# CITY OF ALBUQUERQUE

Re: Certification Submittal for a 120-day Temporary Building Certificate of  
Occupancy (C.O.) for CVS Pharmacy, [A-11 / D011]  
10700 Unser Blvd. NW  
Engineer's Stamp Dated 08/24/11

# DRAINAGE AND TRANSPORTATION INFORMATION SHEET

PROJECT TITLE: CVS Pharmacy @ Unser and McMahon ZONE MAP/DRG. FILE # A-11  
DRB#: 1005280 EPC#: \_\_\_\_\_ WORK ORDER#: \_\_\_\_\_

**SHEET NO.**  
A1.0

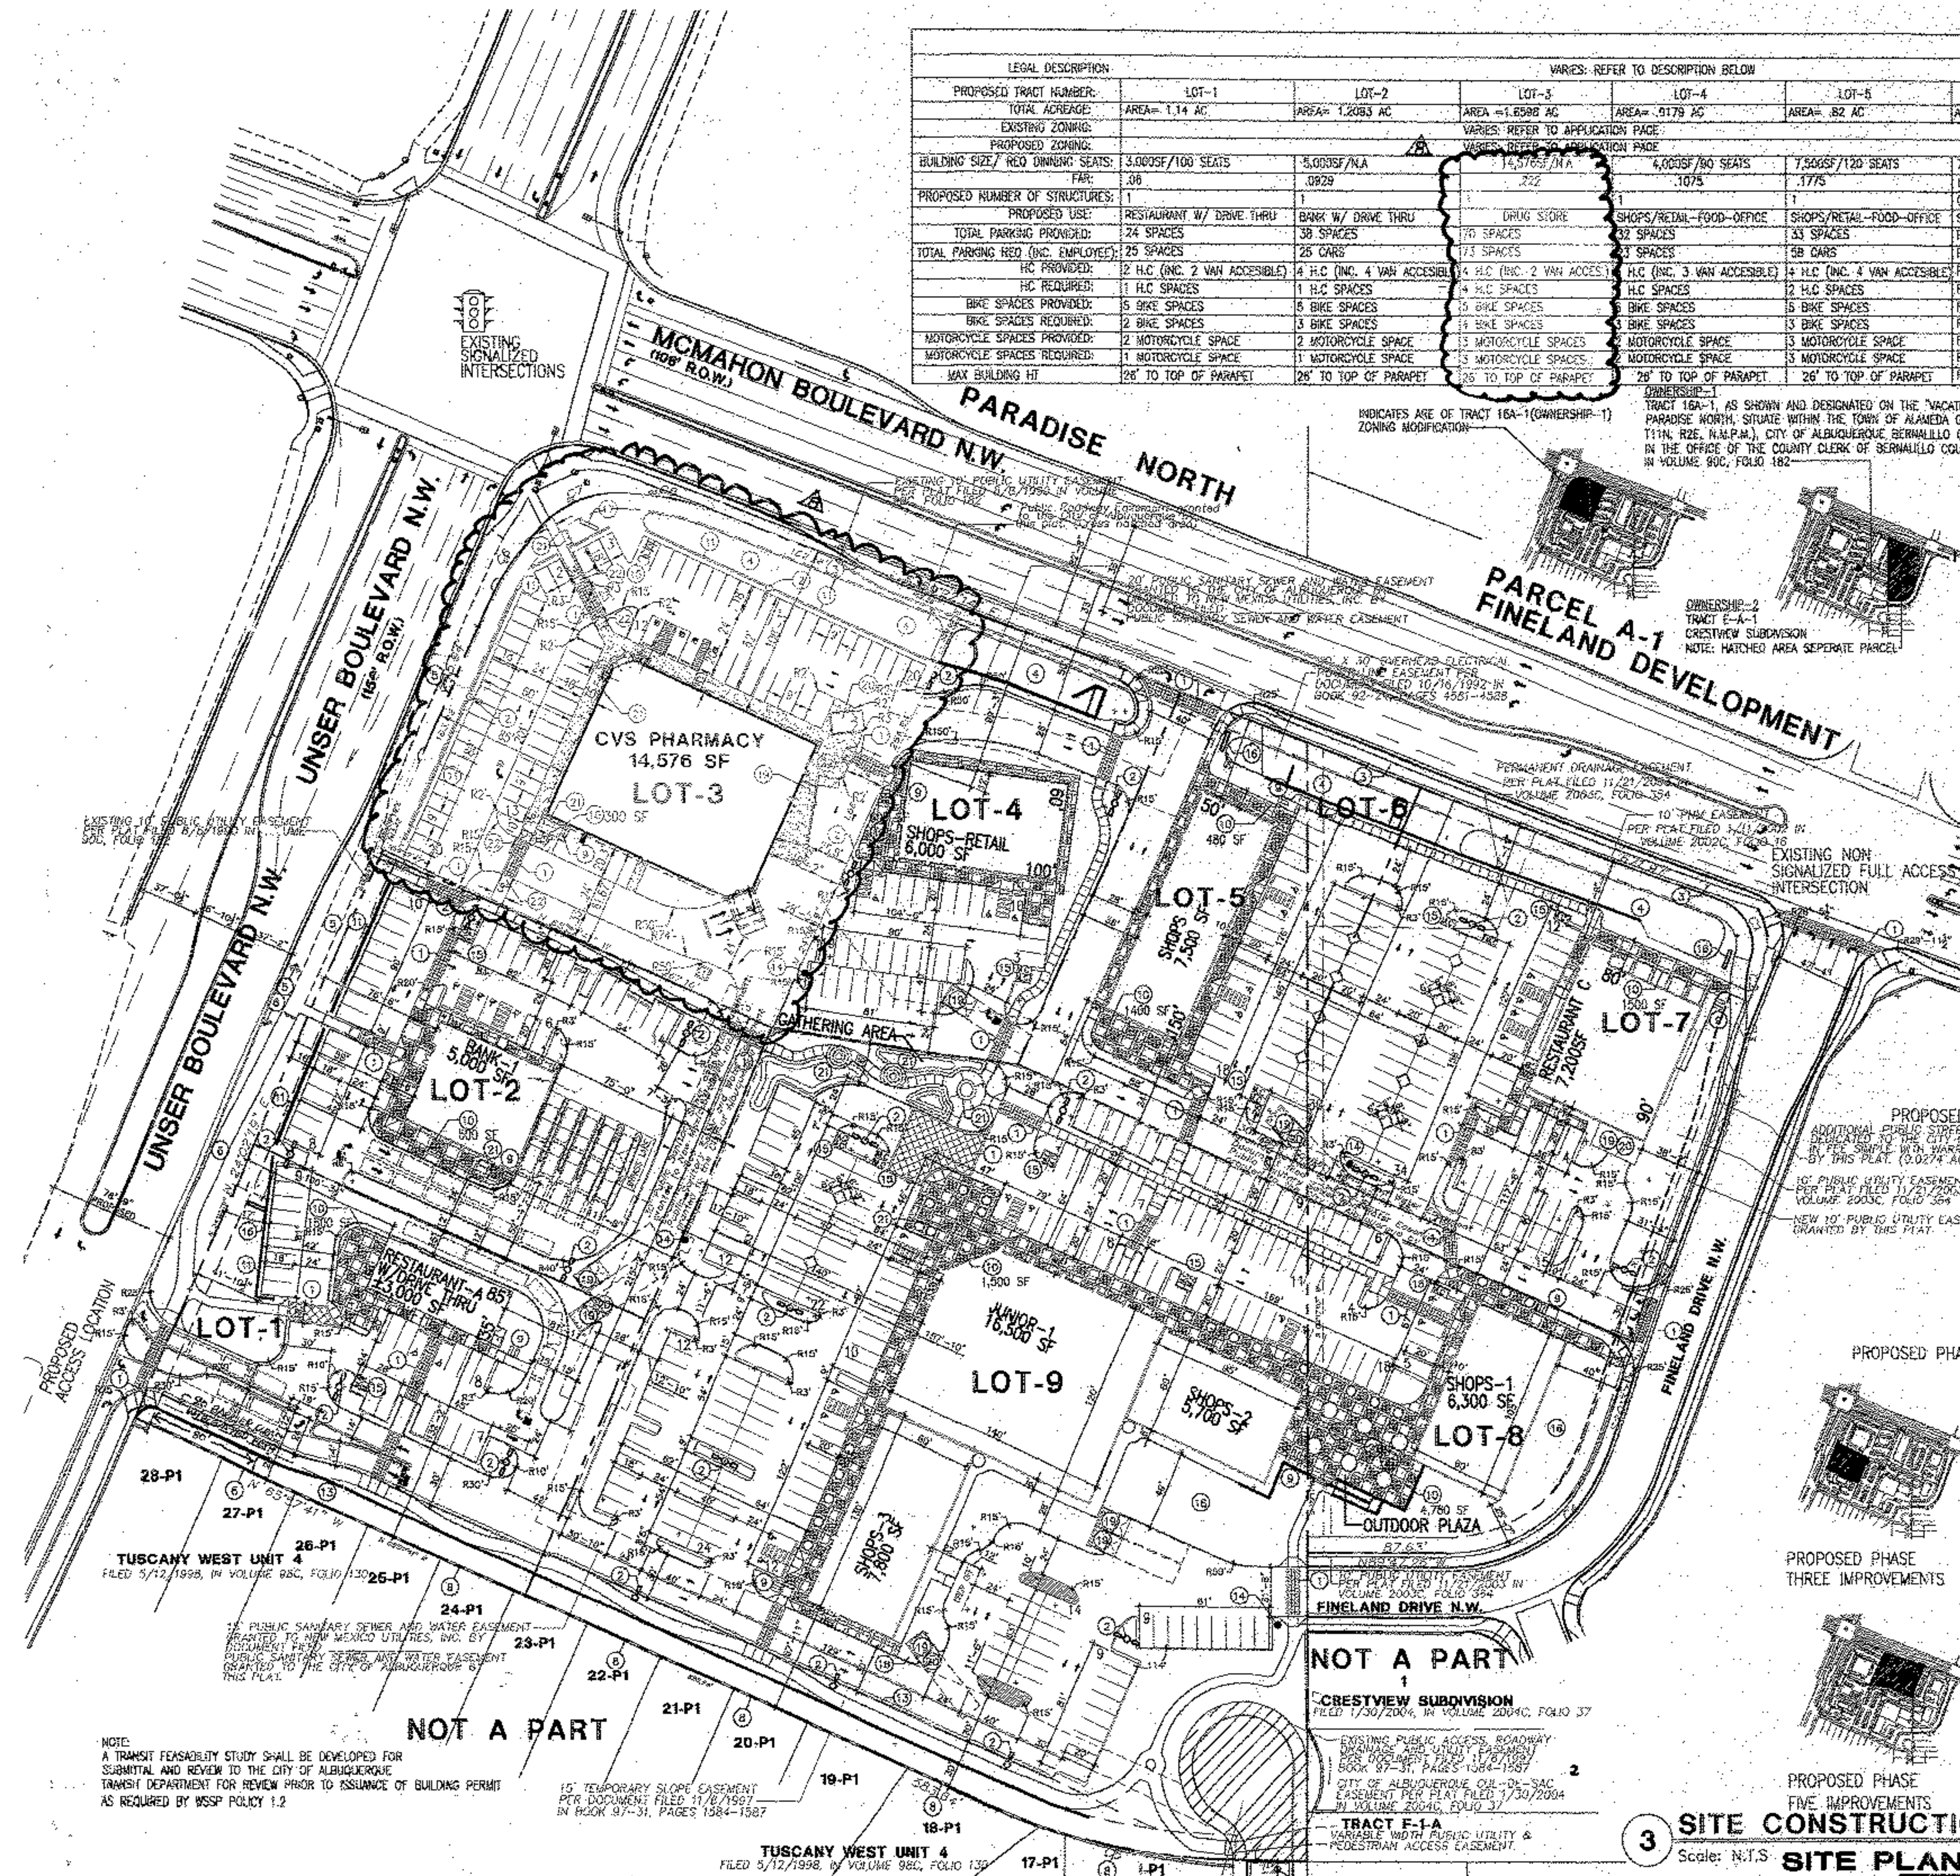
14. ADMINISTRATIVE AMENDMENT  
PARAGRAPH 14.1 POSS. 1400280  
Desired 14.1a fonting  
and spacing  
Revised  
APPROVED BY CS N
